**STANDARD HIGHWAY
SPECIFICATIONS
VOLUMES I & II**

**ADDENDUM No. 1
October 15, 2010**

THE CITY OF NEW YORK
DEPARTMENT OF TRANSPORTATION

THE CITY OF NEW YORK
DEPARTMENT OF DESIGN AND CONSTRUCTION
INFRASTRUCTURE DIVISION
BUREAU OF DESIGN

TEMPORARY PEDESTRIAN STEEL BARRICADE

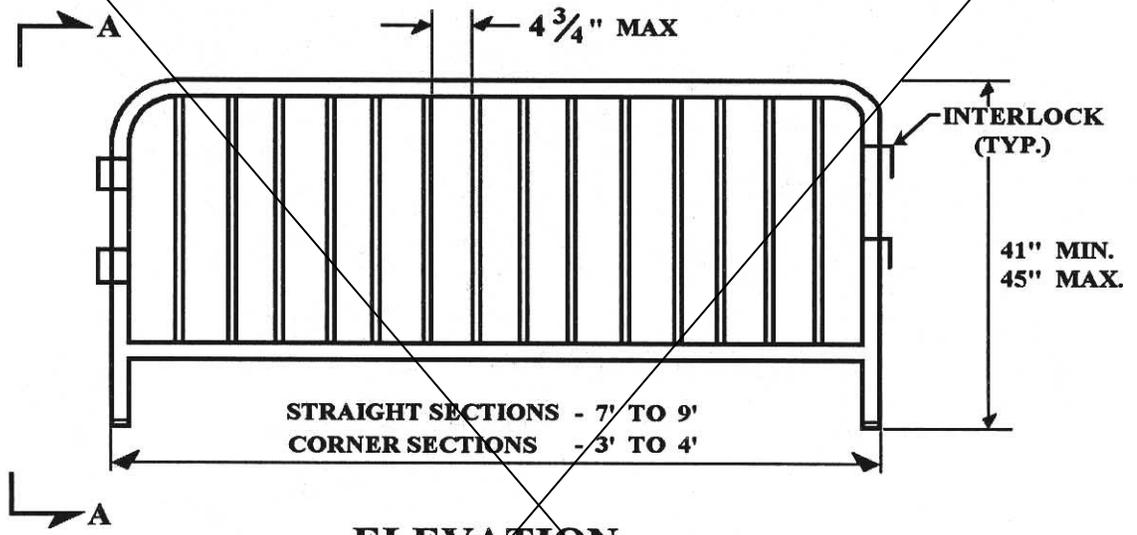
14. Refer to Page 500, **Subsection 7.36.3. MATERIALS**, first paragraph, second and third lines;
Delete in the first paragraph, the second and third lines beginning with the words "on the New York City Department of Transportation's Standard Details of Construction Standard Drawing No. H-1014";
Substitute the following text: "on the following sketch".

15. Refer to Page 501;
Insert the sketch contained on the following page A1-2d.

26. Refer to Page 500, **Subsection 7.36.3. MATERIALS**, first paragraph, second and third lines as amended by Article 14, above;
Delete in the first paragraph, the second and third lines the words “on the following sketch”;
Substitute the following text: “on the New York City Department of Transportation’s Standard Details of Construction Standard Drawing No. H-1014”.

27. Refer to Page 501 as amended by Article 15, above;
Delete the Pedestrian Steel Barricade sketch, as contained on page A1-2d, in its entirety.
